Re: Request for Superseding Order of Conditions (SOC)

41-119 Baxter Road, Nantucket, MA

DEP File No. SE48-3736

Page 1. THE PROJECT AT A GLANCE: SE48-3736 SCONSET GEOTUBE EXPANSION

1. The beach fronting the existing geotubes has narrowed 45 feet in 10 years.

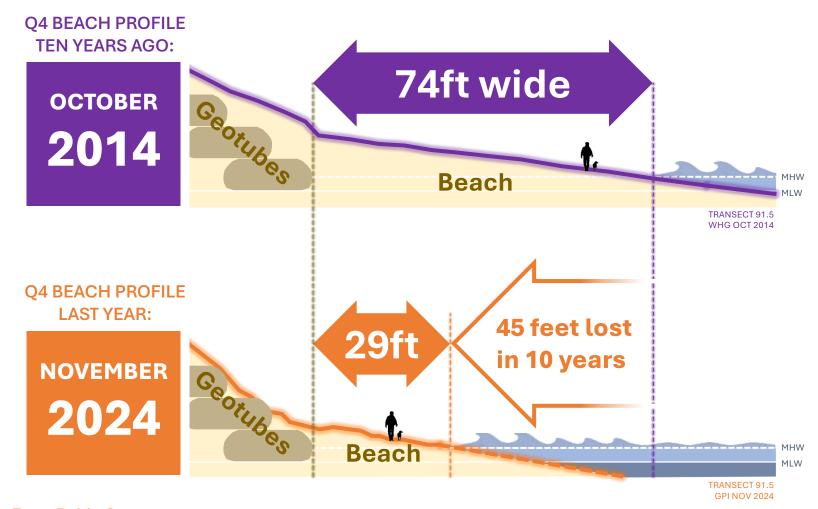
"The beach in front of the geotubes continues to narrow and steepen, with both horizontal retreat and vertical cutting ('passive erosion') typical of seawalls." - Dr. David Kriebel, PhD, PE, submitted 2/6/25

2. Downdrift of the existing geotubes, the erosion rate has accelerated eight-fold.

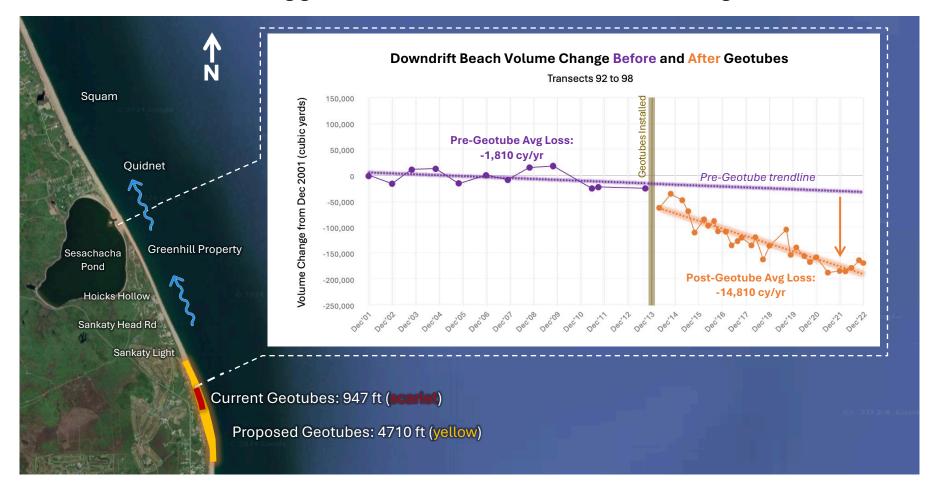
"Data indicate notable temporal changes to beach behavior before and after geotube installation, with dramatically increased erosion rates downdrift following geotube installation... Substantial changes have occurred that correlate both spatially and temporally to the geotubes. Erosion has worsened downdrift of the existing geotubes and this should give pause to the idea of expanding the geotubes and potentially further increasing these effects."

3. The mitigation sand deficit has likely contributed to downdrift volume loss.

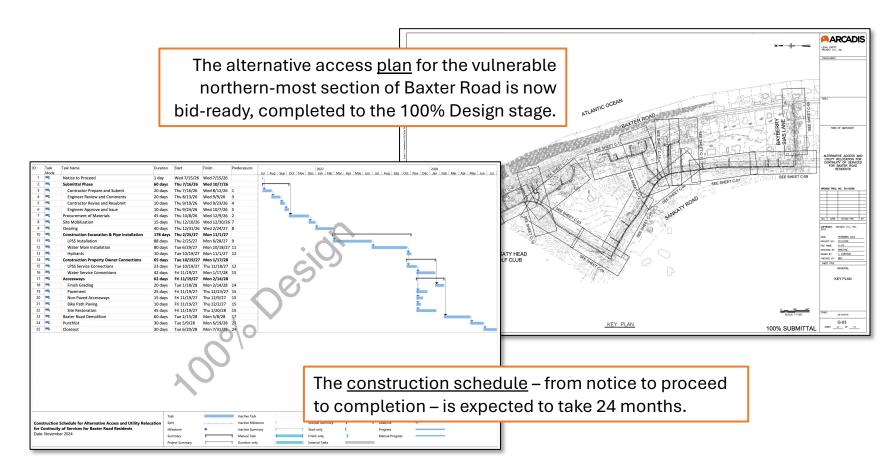
Judging from Woods Hole Group survey data charted below, it is reasonable to postulate that:

- a) Were it not for the mitigation sand provided (green line), downdrift volume loss (orange line) would likely have been worse;
- b) By this same reasoning: had the full mitigation volume required in the permit (blue line) been provided, downdrift volume loss (orange line) would likely have been less severe;
- c) It follows that the sand deficit (red arrow) has likely contributed to downdrift volume loss (orange line):

• "This lack of mitigation sand provides an explanation for much of the -14,810 cy/yr loss of beach volume downdrift of the geotubes." – <u>Dr. David Kriebel, PhD, PE submitted 8/2/24</u>

Option 2: Adapt Road Layout via Alt Access Construction

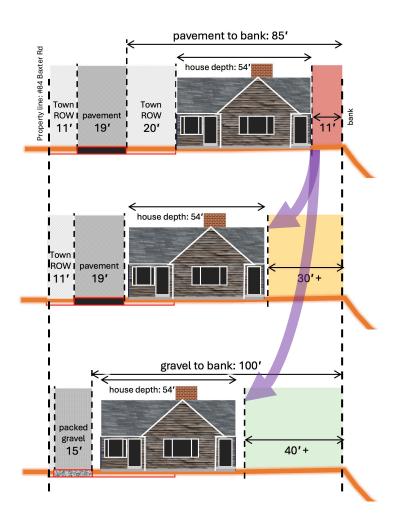
- Arcadis' Alternative Access & Utility Relocation Plan calls for conversion of northern Baxter Road from pavement to a narrower roadway of packed gravel. Narrowing of the road would expand easement opportunities for bluff-side homeowners.
- As part of the project, the Town could install the gravel roadway nearer the landward side of the Town ROW to further expand easement opportunities.

3. A "sand-coir berm" alternative offers many advantages over hard-armoring.

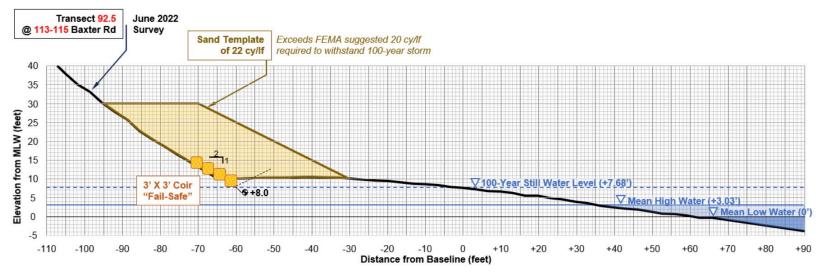
"FEMA has codified what coastal engineers call the '540 Rule', which states that a primary sand dune should have a cross-sectional area of ≥540 square feet – i.e., a volume per unit length of 20 cy/lf – to provide an effective storm barrier in a 100-year coastal storm. By this standard, if SBPF were to adaptively maintain 22 cy/lf of sand at the toe of the bluff as proposed, it would have the potential to provide protection to the bluff from erosion in a 100-year storm event without use of geotubes. Protection could be enhanced by a coir bag terrace system as a failsafe." The "Sand-Coir Berm" shown below is based on June 2022 beach profile for transect 92 (WHG data):

- 1. Satisfies the applicants' interest in protecting bluff from erosion in storms up to a 100-year return period.
- 2. Satisfies interests of downdrift property owners, as sand would be freely available to the littoral system.
- 3. Satisfies interests of community and environmental groups with a fully nature-based approach.
- 4. Consistent with WPA, a reasonable alternative to a mile-long coastal engineering structure.
- 5. Less costly and complex in terms of installation; would not require further engineering study.
- 6. Essentially self-removing: once adaptive mitigation is discontinued, the berm would naturally erode; the only required action would be removal of coir bags at the end of their service life.

1. The applicants have provided no monitoring of the project area since 2022.

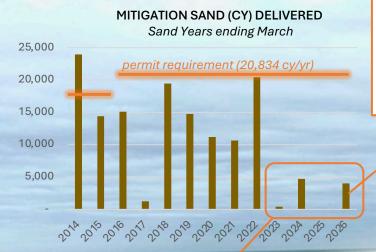
Orange squares indicate Woods Hole Group (WHG) surveys.											
2014	2015	2016	2017	2018	2019	2020	2021	2022	2023	2024	2025
JAN	JAN	JAN	JAN	JAN	JAN	JAN	JAN	JAN	JAN	JAN	JAN
FEB	FEB	FEB	FEB	FEB	FEB	FEB	FEB	FEB	FEB	FEB	FEB
MAR	MAR	MAR	MAR	MAR	MAR	MAR	MAR	MAR	MAR	MAR	MAR 000
APR	APR	APR	APR	APR	APR	APR	APR	APR	APR	APR	APR
MAY	MAY	MAY	MAY	MAY	MAY	MAY	MAY	MAY	MAY	MAY	MAY
JUN	JUN	JUN	JUN	JUN	JUN	JUN	JUN	JUN	JUN	JUN	JUN
JUL	JUL	JUL	JUL	JUL	JUL	JUL	JUL	JUL	JUL	JUL	
AUG	AUG	AUG	AUG	AUG	AUG	AUG	AUG	AUG	AUG	AUG	
SEP	SEP	SEP	SEP	SEP	SEP	SEP	SEP	SEP	SEP	SEP	
ОСТ	ОСТ	ОСТ	ОСТ	OCT	OCT	OCT	OCT	ОСТ	OCT	OCT	
NOV	NOV	NOV	NOV	NOV	NOV	NOV	NOV	NOV	NOV	NOV	— Independent 3D
DEC	DEC	DEC	DEC	DEC	DEC	DEC	DEC	DEC	DEC	DEC	photogrammetry survey re: condition of bank & beach.

- After a year with no mitigation, monitoring or maintenance, the NOI was submitted to the Commission in December 2023. In virtually every public hearing and through numerous written submissions (link: <u>example</u>), the Commission heard repeated public requests for up-to-date survey data prior to the issuing of an OOC, particularly in light of the observed deterioration of the fronting and downdrift beaches. The Commission took no action on those requests.

- Two years after the last WHG survey, members of this residents group commissioned an independent photogrammetry survey of the entire project area, executed by GPI in **November 2024**. The <u>findings from that survey</u> were presented to the Commission on 2/13/25, and summarized in a <u>letter submitted 2/6/25</u> by Dr. Kriebel, PhD, PE. Those findings inform this document and multiple documents in the public record, but are not reflected in the OOC.

3. Recent data shows that even if geotubes can be expanded, their service life will likely be brief.

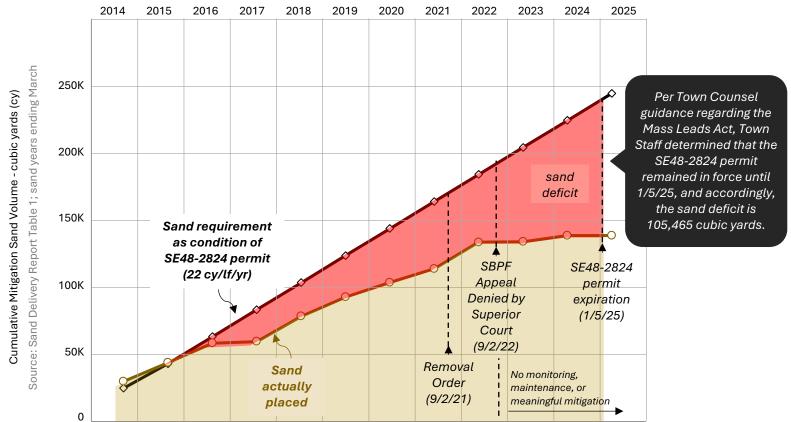
The orange line below shows the beach profile at Transect 92, NOV 2024 PHOTOGRAMMETRY @ TRANSECT 92 immediately north of the existing geotubes, as of November 60-80 ft for 2024. Adding geotubes and an excavation trench as shown in Excavation the permit drawings makes it apparent that insufficient beach space now remains to install geotubes landward of MHW: 50 ft width of NOV 2024 TRANSECT 92 PROFILE WITH PROPOSED EXCAVATION **Excavated** 30 Sand Elevation from NAVD88 (feet) 25 Stockpile Geotube otogrammetry survey 11/18/24, Greenhill family Geotube 10 Geotube Geotube -4.8ft MLW -1.88' NAVD88 -110-100-70 -30 -20 -10 10 20 30 40

- "Erosion has reduced the beach width available for construction. Based on permitting designs, the excavation trench would extend well into the active wave uprush zone, and in certain places may be at or seaward of the Mean High Water (MHW) line. This would violate Condition #32 of the OOC, and would mean that a Chapter 91 wetland license would be required prior to construction. Any crossing of MHW would occur on Town-owned land."
- Given that Failure Criterion #67f of the OOC calls for maintaining a minimum of 15 ft between MHW and the geotubes, "...even if geotubes could be legally installed, their service life would likely be at best very brief."

2. The OOC's 10-year allowance for rectifying the deficit is too lenient – twice the duration of the new permit – and without basis.

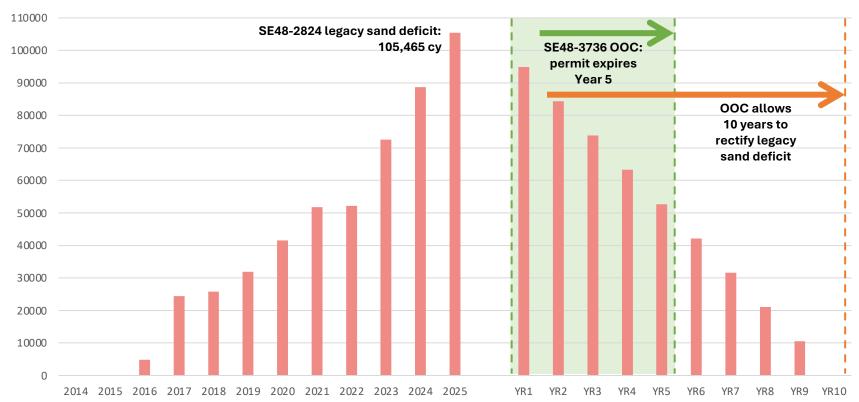
"Requiring the full volume of make up sand is vital to the neighboring resource area. Making up over ten years is too long and should be done over five years at most, i.e., within the life of the permit."
